Architect's Supplemental Instructions

Wilma P Mankiller Expansion
Stilwell, OK

ASI Number: Bid Package 02 ASI 07

Construction Documents – ASI 07 – Wilma P. Mankiller Health Center Expansion

SHEET NUMBER:
CP101

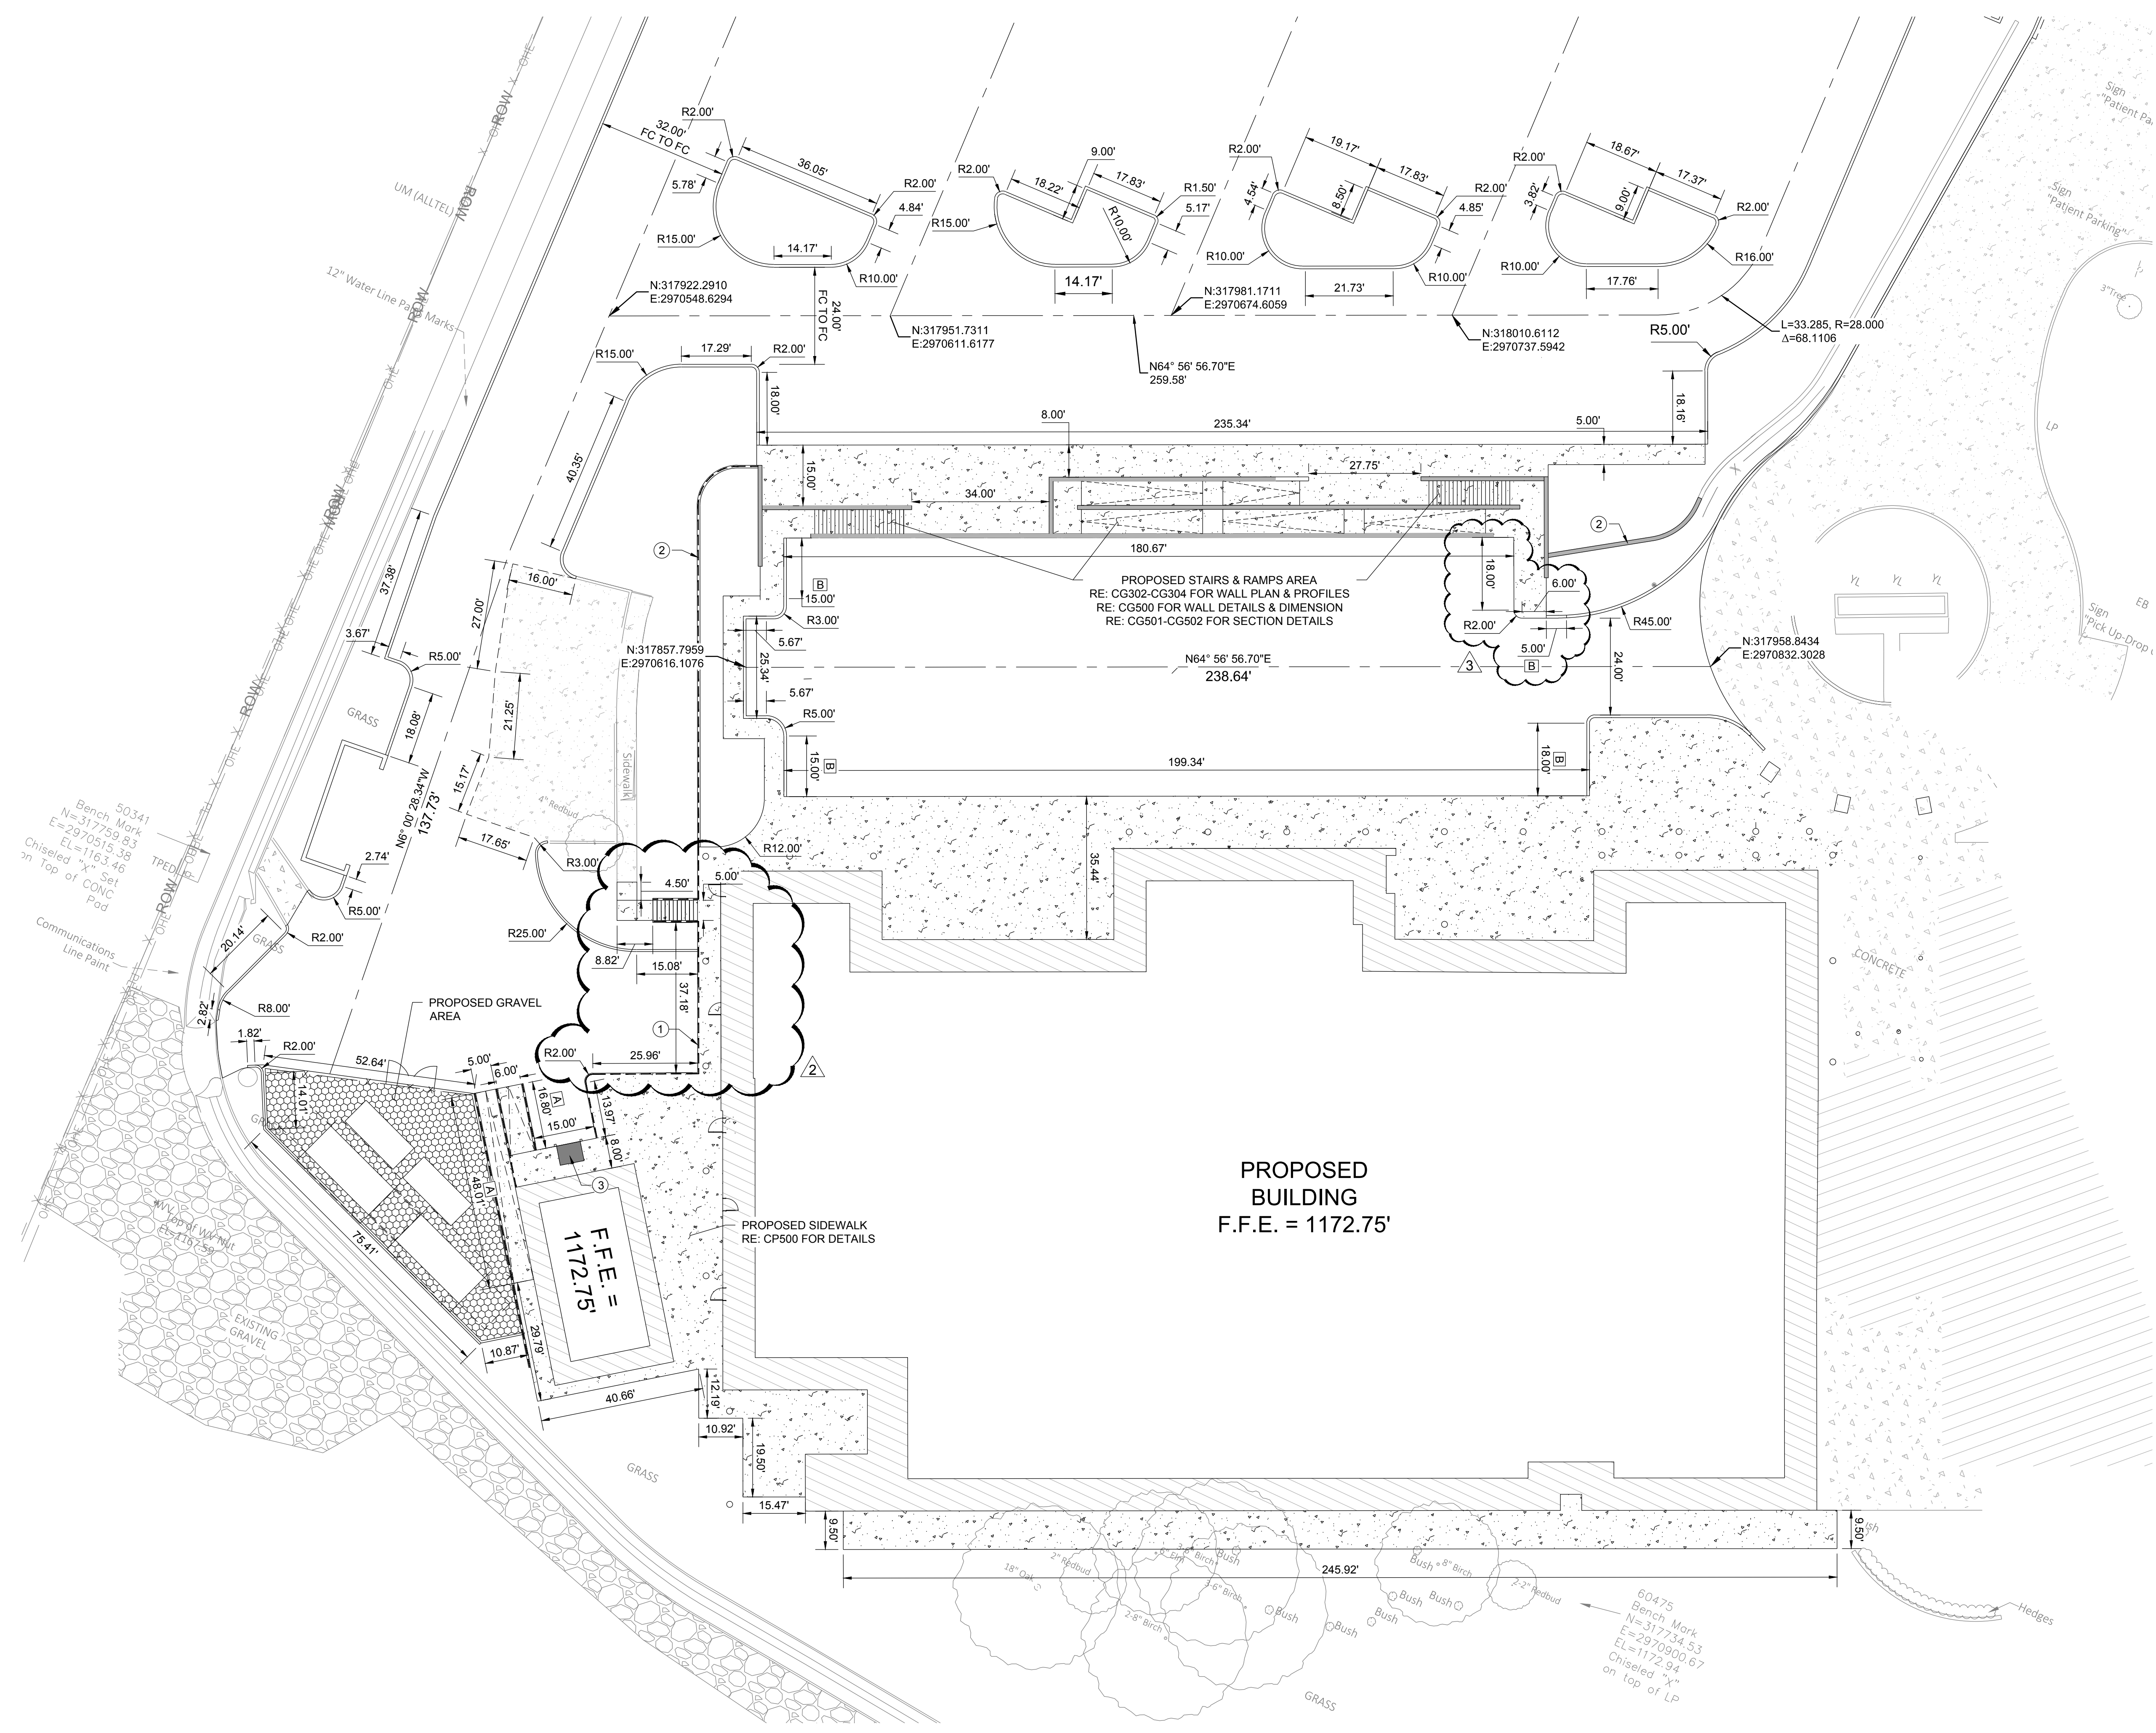
CP101

1. Modified curb and sidewalk near wall (East side)

SHEET NUMBER: CG103

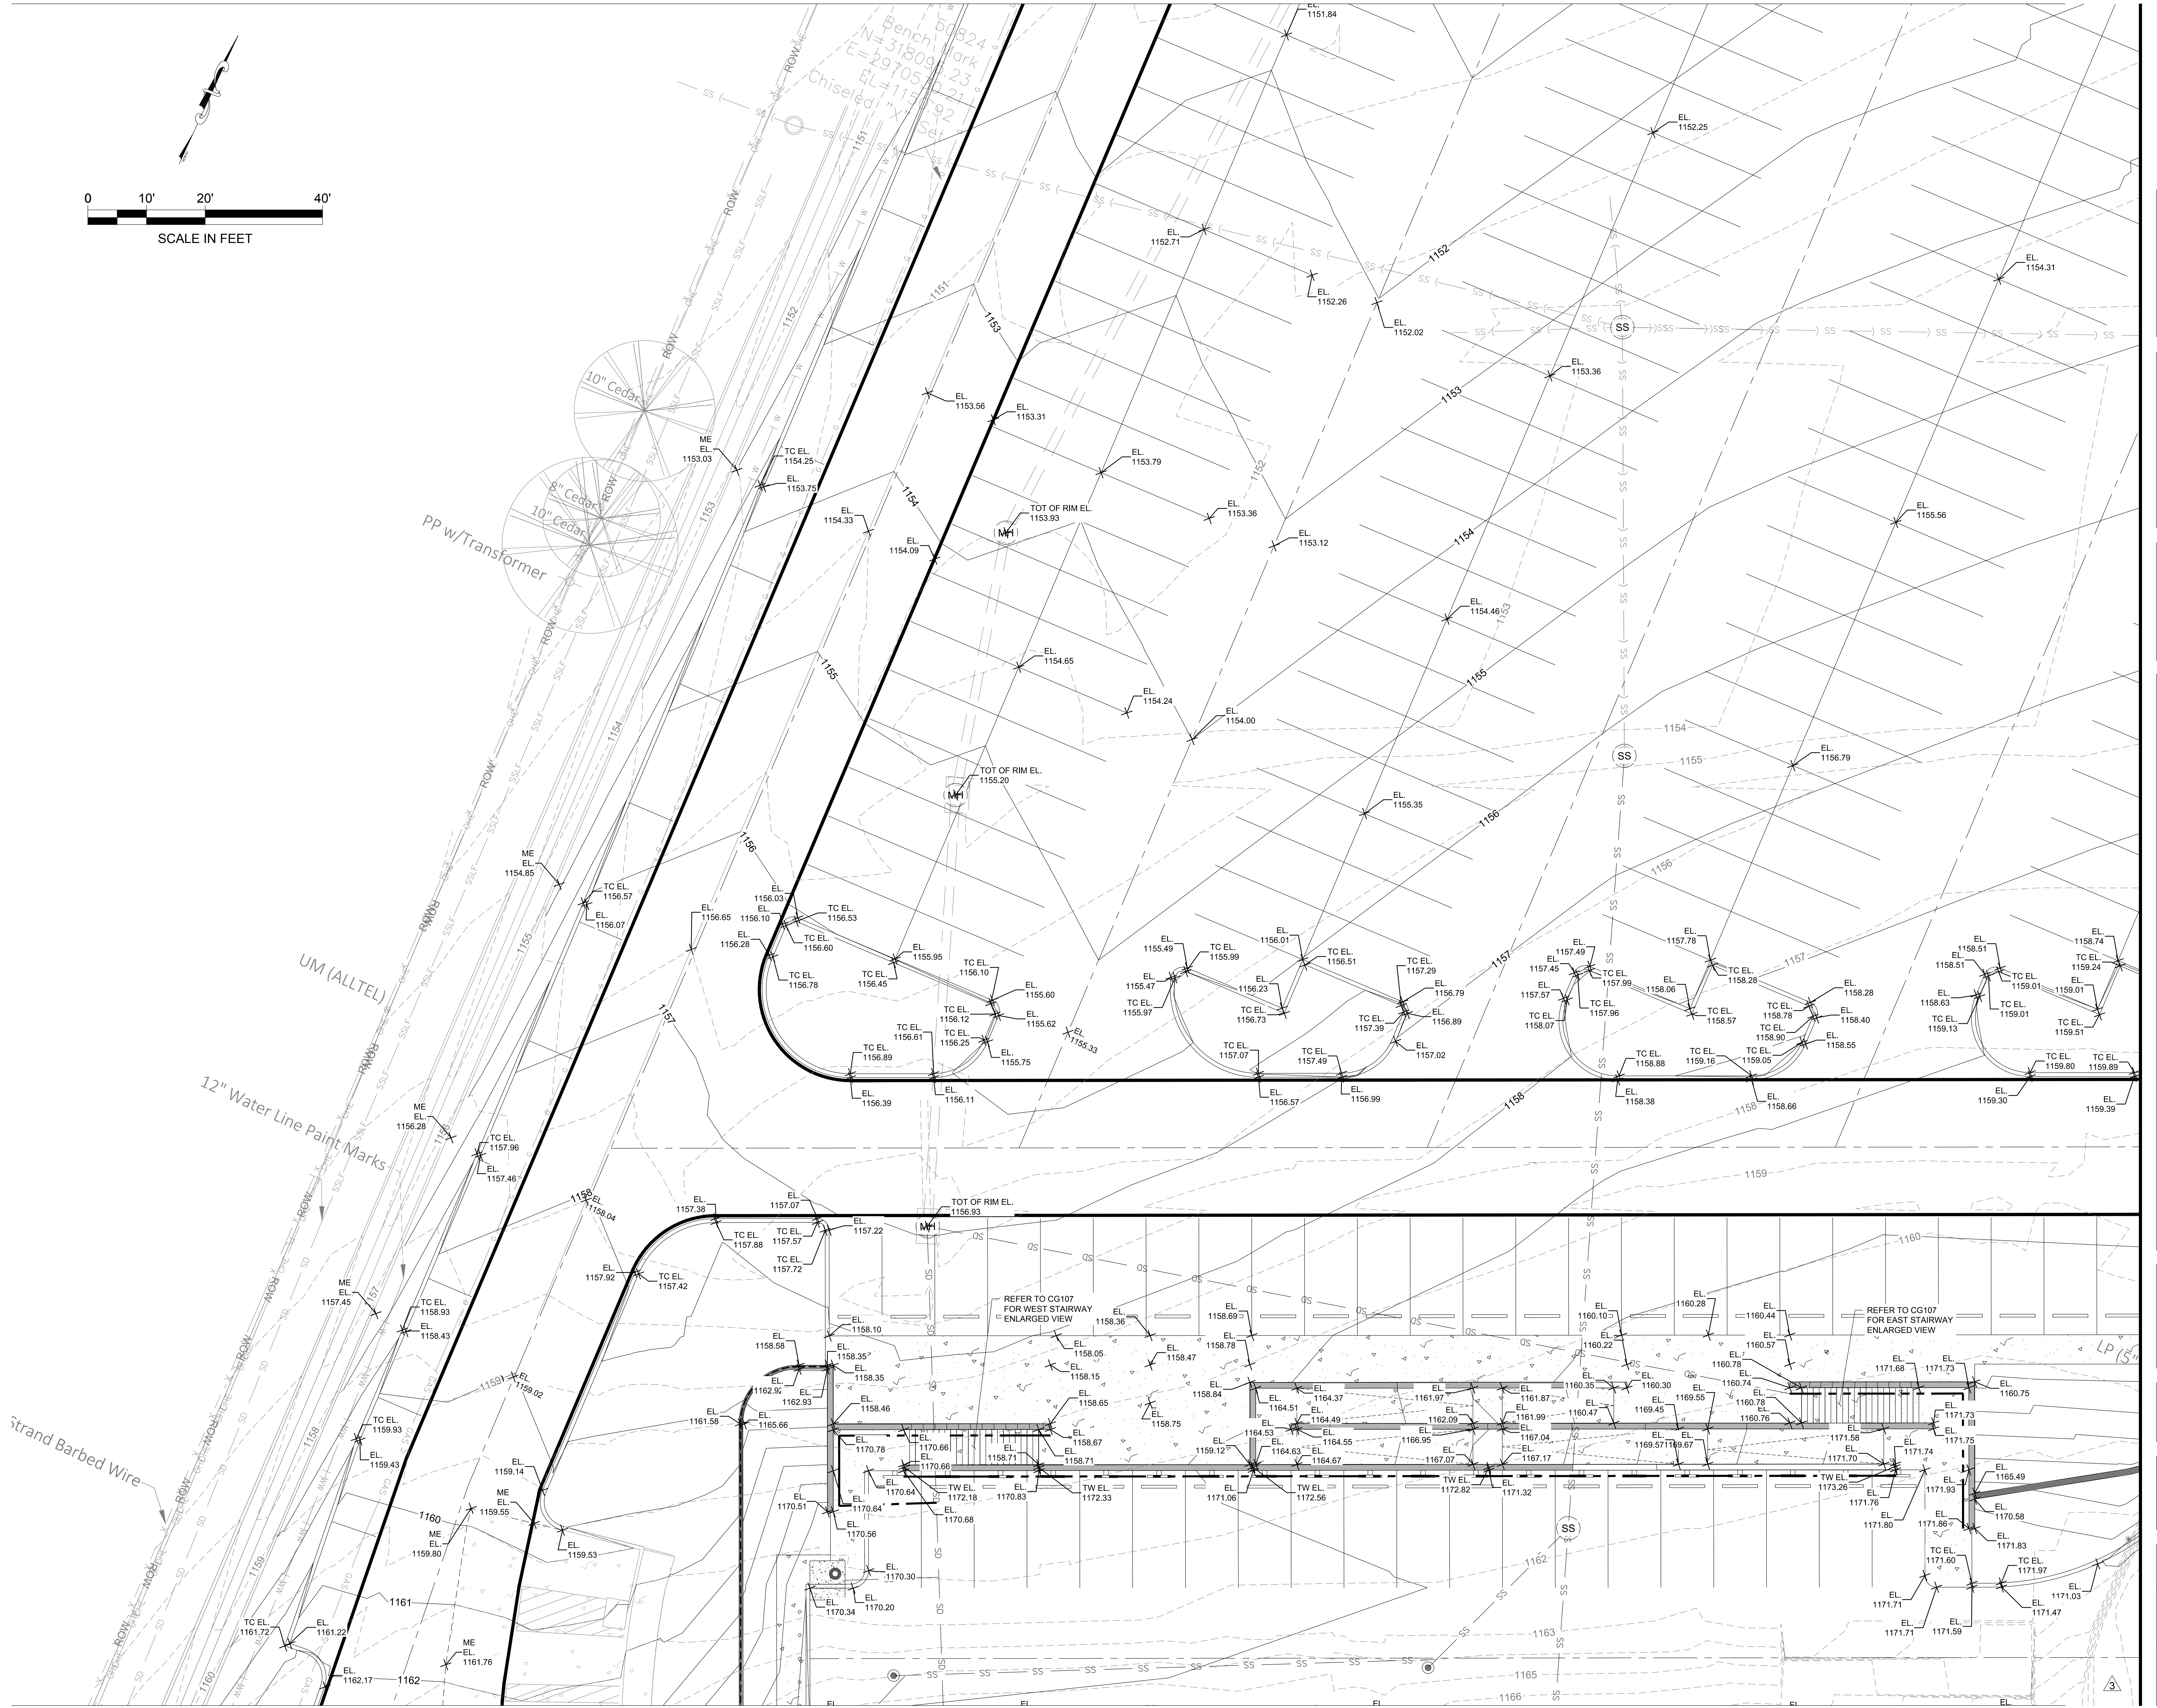
CG103

1. Added top of wall elevations on main wall to note the change, added points on the sidewalk next to wall

WALL ALIGNMENT - 5 PROFILE
(STA. 19+95 - STA. 21+85)

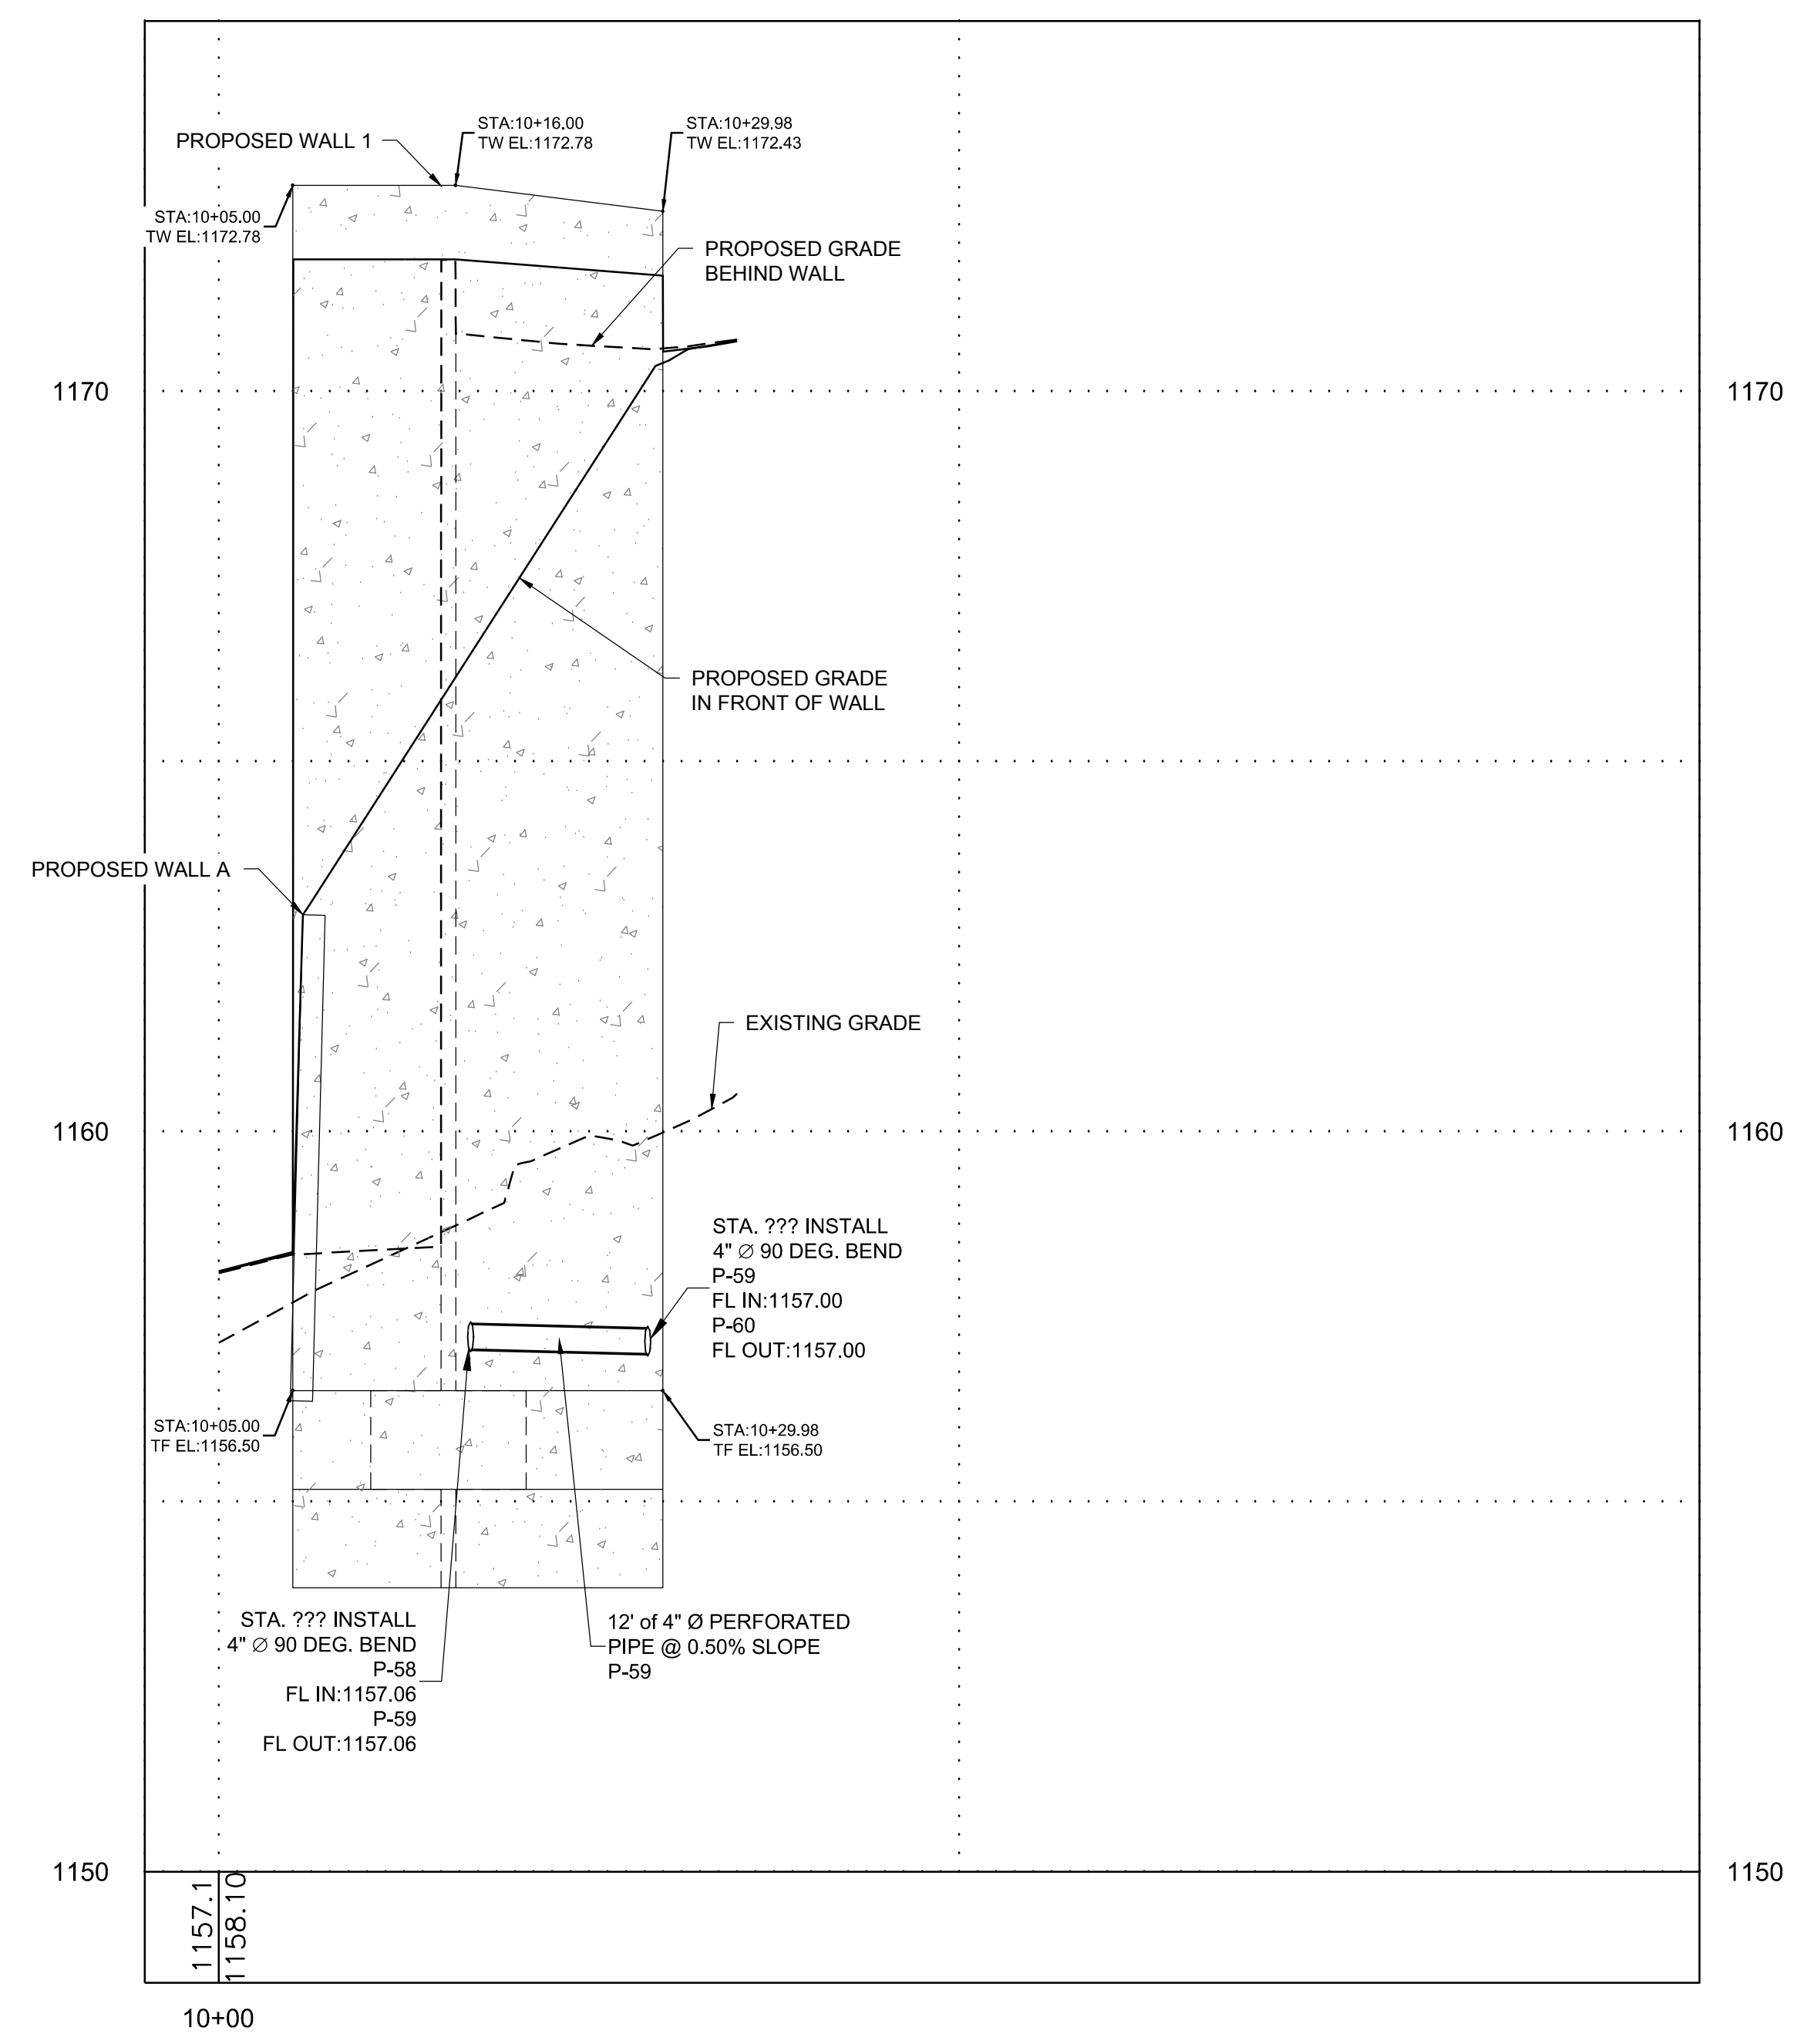
CG304

1. Raised the top of wall elevation on profile alignment 5
